**TOWN OF NEWBURGH  
PLANNING BOARD  
TECHNICAL REVIEW COMMENTS**

**PROJECT: MOZO PROPERTIES SITE PLAN**  
**PROJECT NO.: 16-11 (PREVIOUSLY 15-17)**  
**PROJECT LOCATION: SECTION 34, BLOCK 2, LOT 55**  
**REVIEW DATE: 31 JANUARY 2019**  
**MEETING DATE: 7 FEBRUARY 2019**  
**PROJECT REPRESENTATIVE: TALCOTT ENGINEERING**

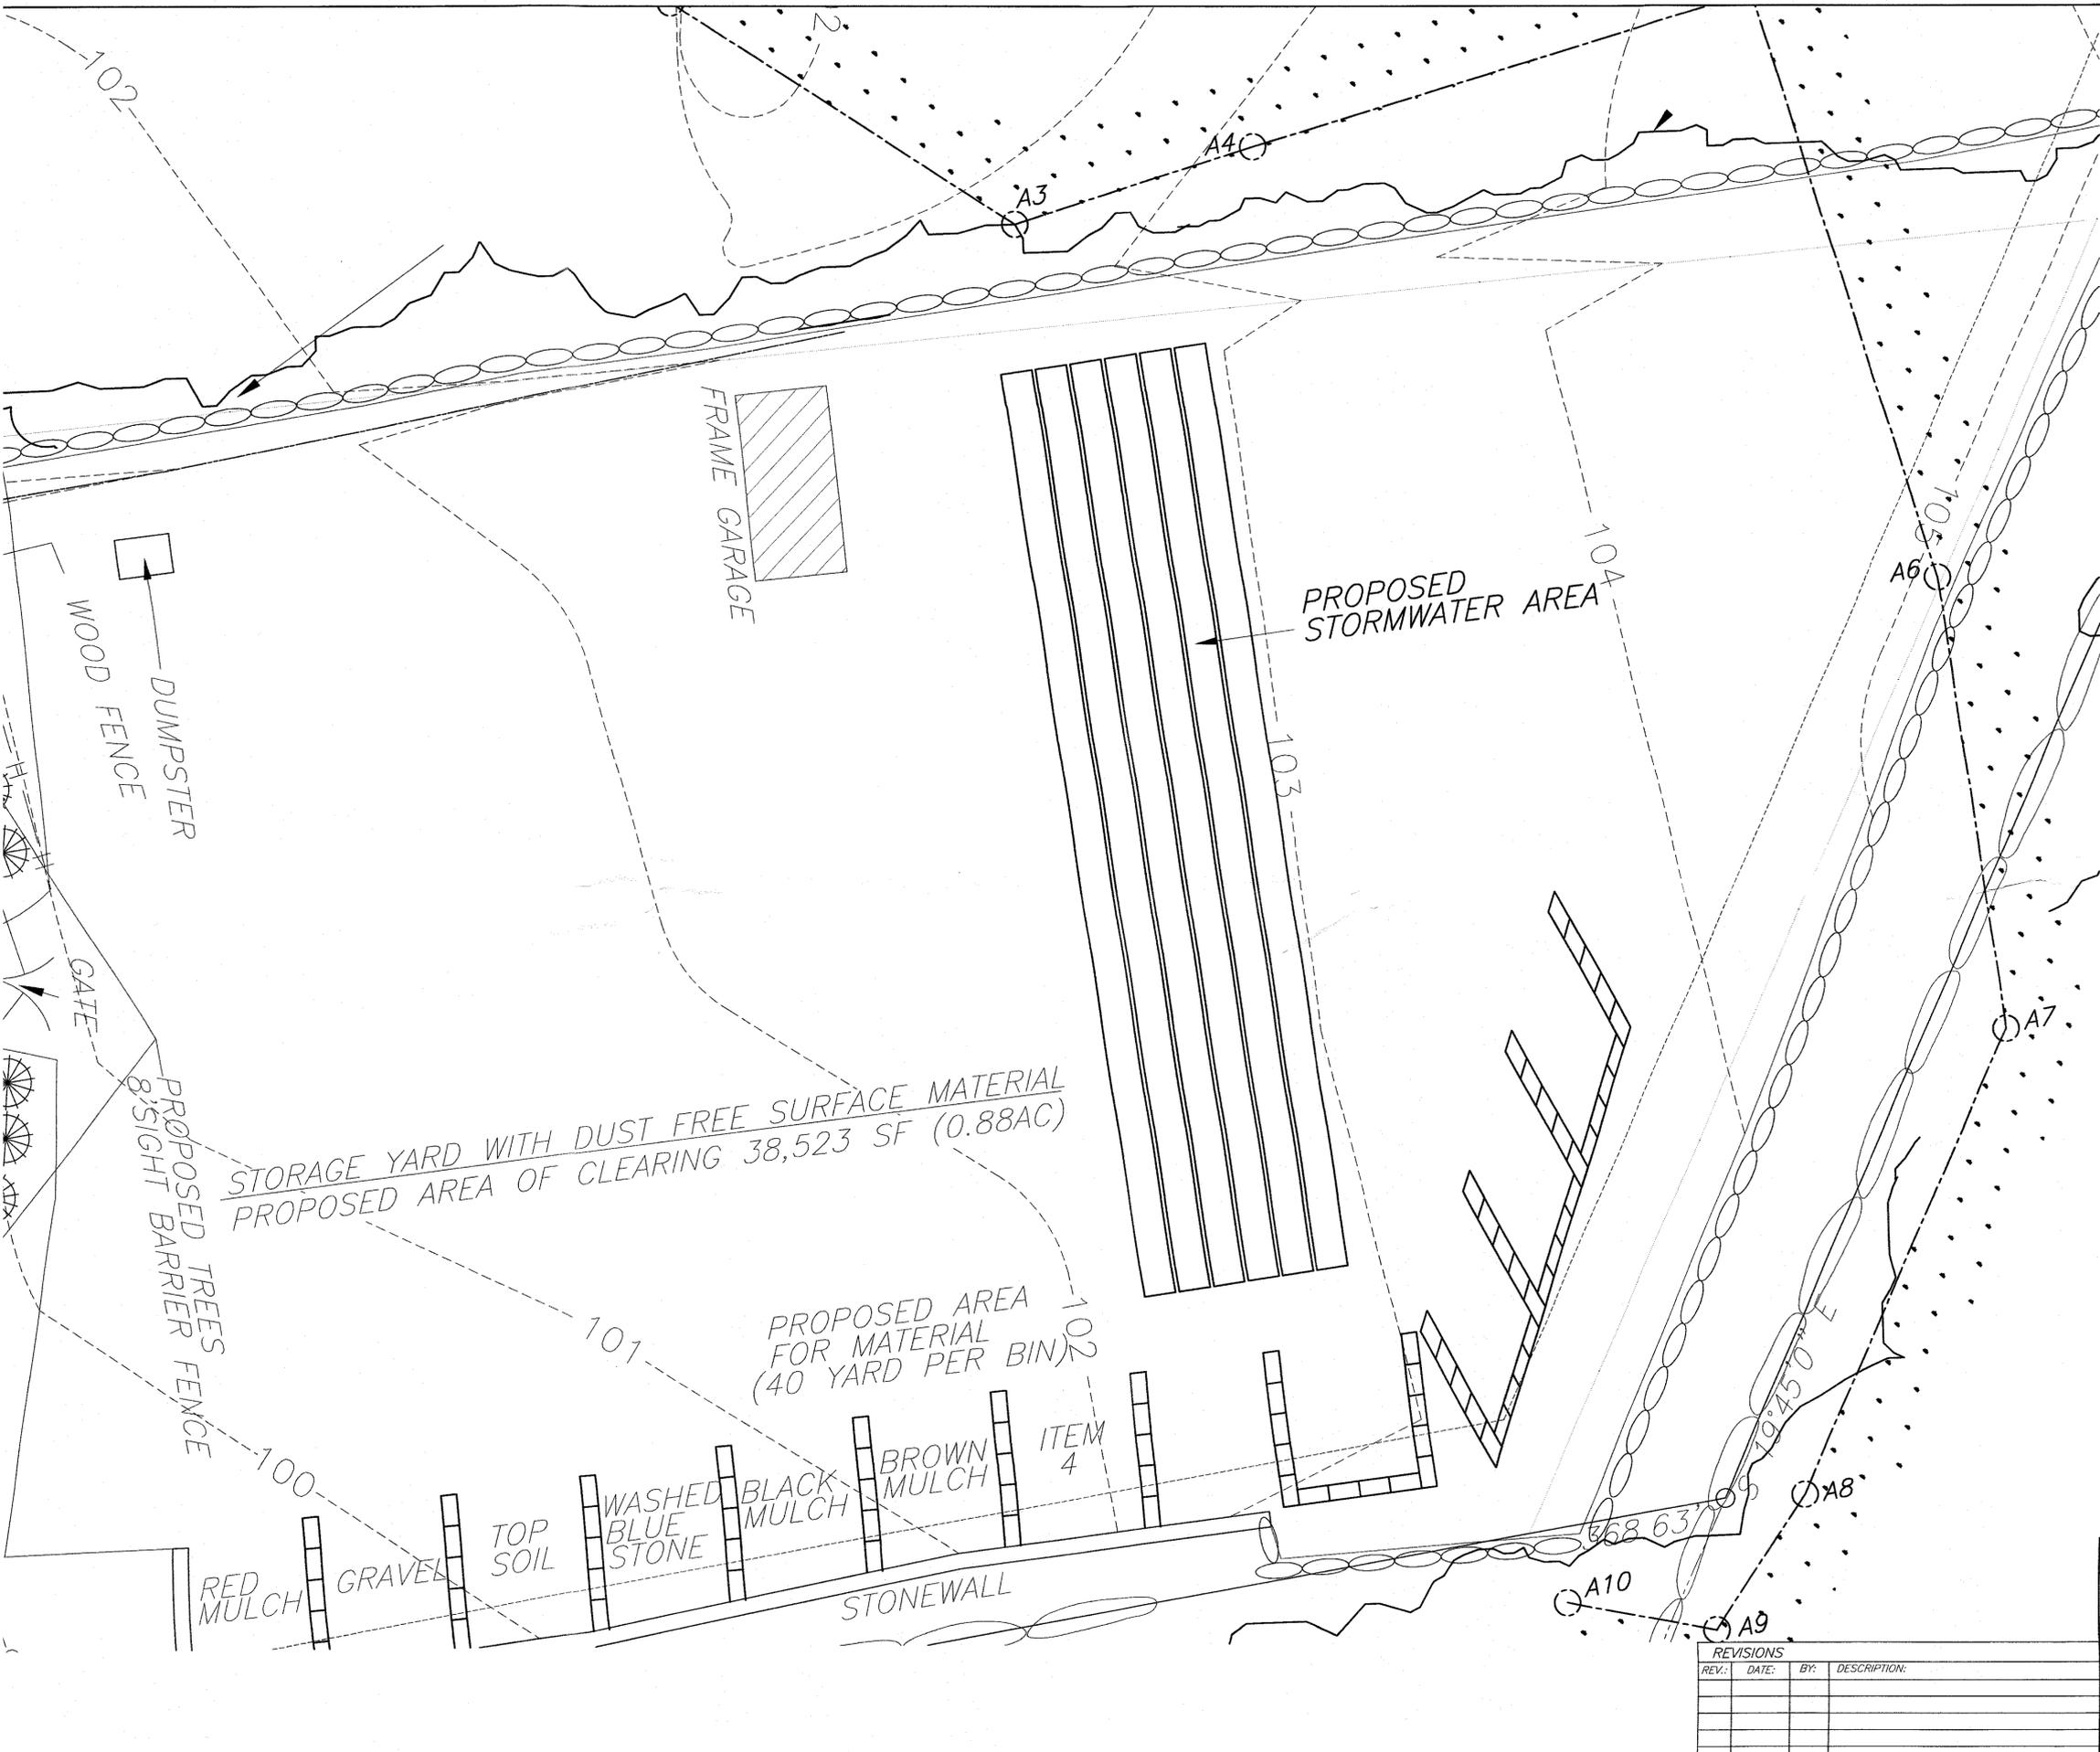
3. Compliance with Section 185-30 Outdoor Storage should be documented. "All outdoor storage areas shall be appropriately screened with landscaping as to provide an opaque site barrier at least 8 feet in height. In no case shall material be stored in excess succeed the height of the sight barrier."

4. NYSDOT approval for a commercial driveway access is required.
5. Site lighting should be identified on the plan.
6. Landscaping details should be submitted identifying number of plant species and planting details for the Board's review. The Board should review the adequacy of the proposed screening with regard to outdoor storage. Applicants are apparently proposing landscape screening in lieu of a fence, however the screening is labeled "proposed tress 8 foot sight barrier fence". If no fence is proposed the area should be only identified as a landscape screening.

7. It is recommended that the stone wall along the westerly portion of the storage yard be preserved as a site plan feature to limit access to the Federal Wetland areas located west of the proposed area for activities.

8. Details for the proposed gate identified on the plans should be provided. Materials of the gate in conjunction with the outdoor storage screening requirements should be clearly defined.
9. A 30 inch high dry laid field stone wall is proposed along the frontage.

**CULTEC RECHARGER 280HD SPECIFICATIONS**

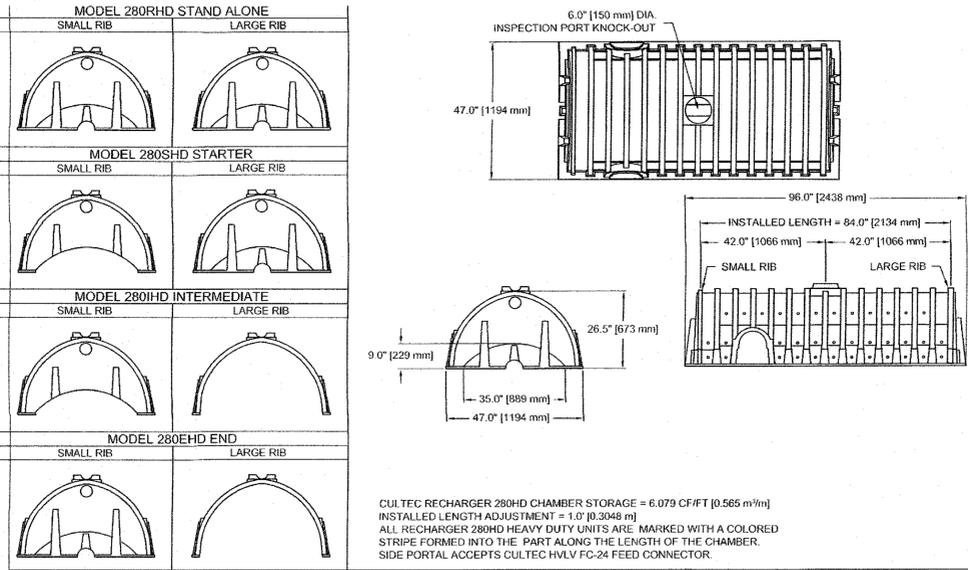
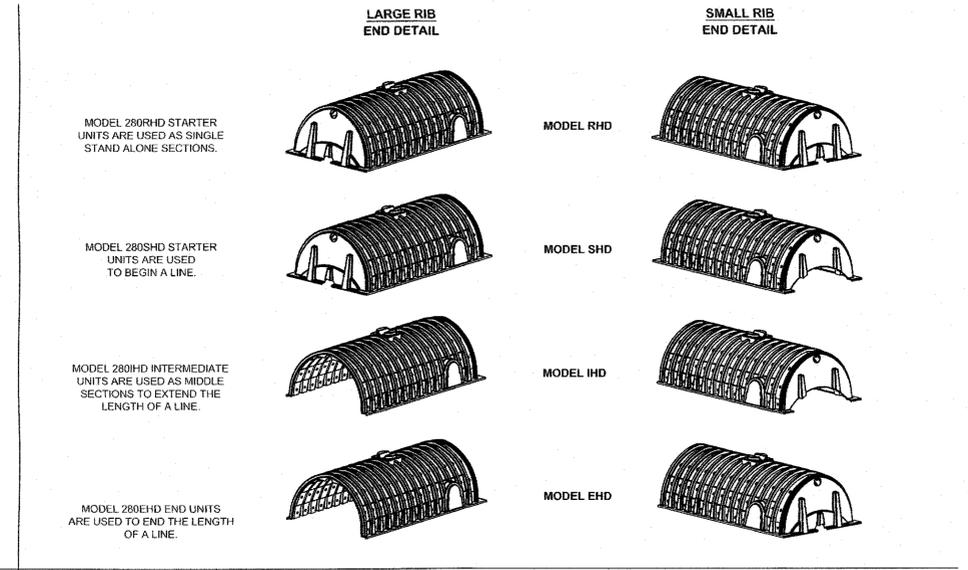
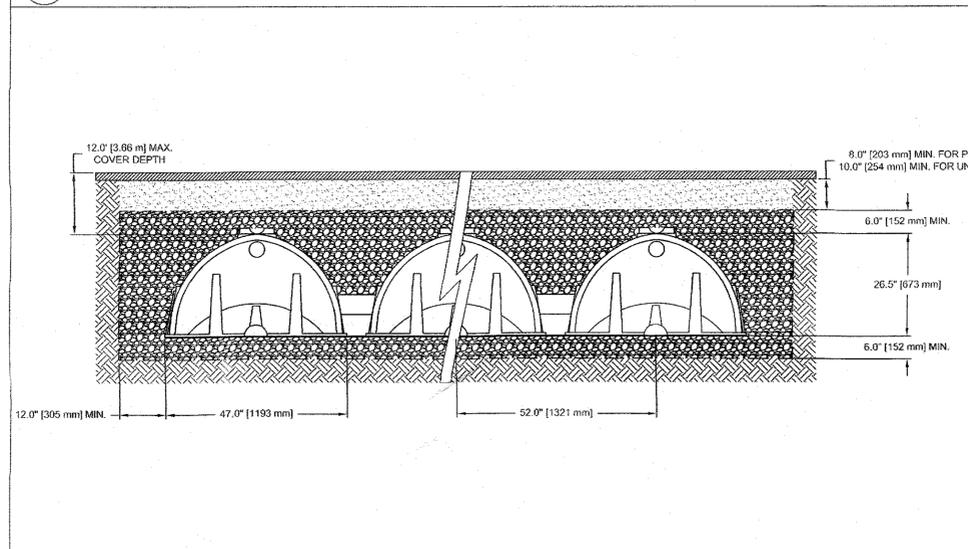
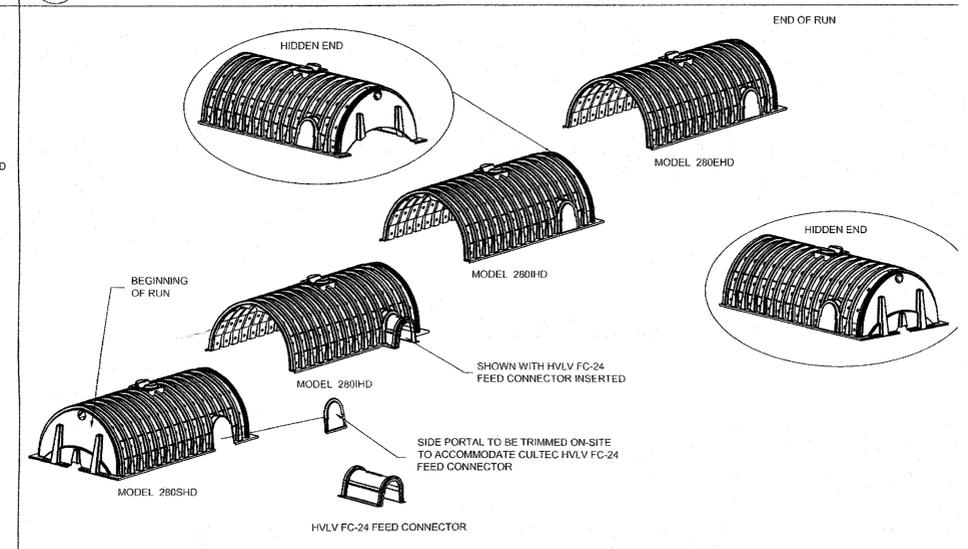
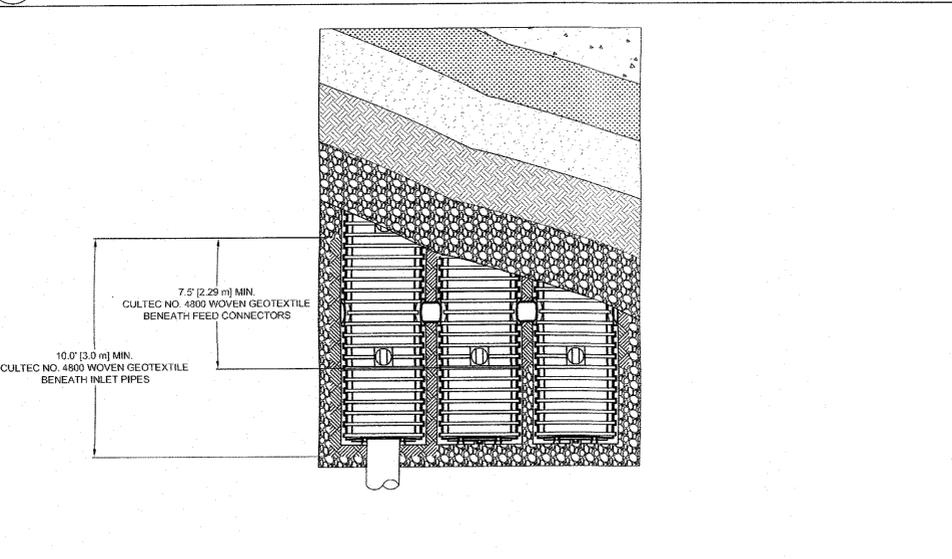
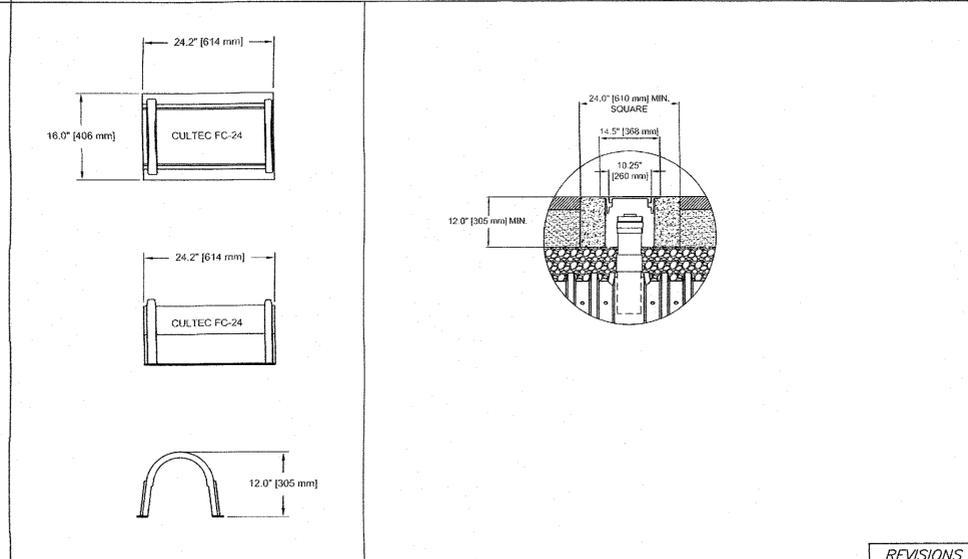
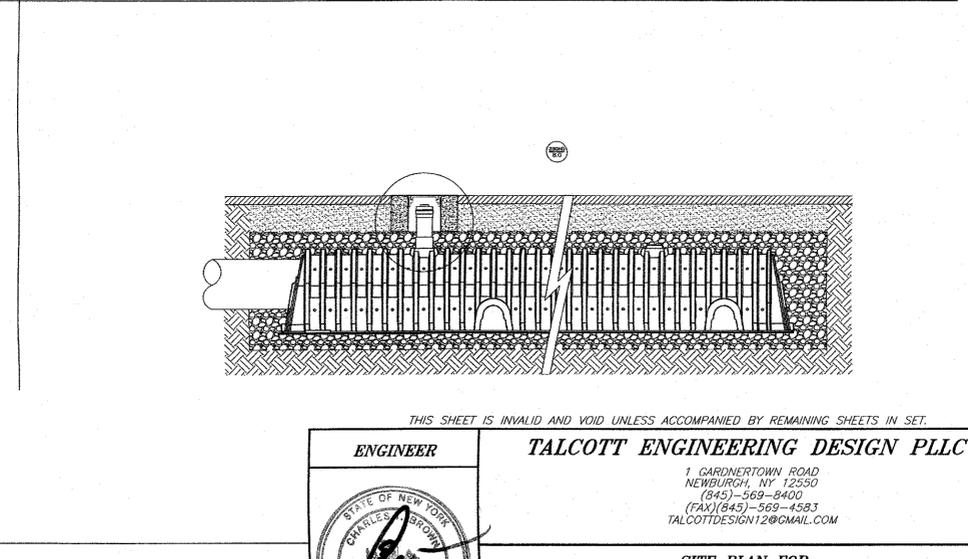
2. The Applicant's re-submission letter identifies that stormwater management plans and reports will be forthcoming. Schematic details from a manufacturer have been provided.
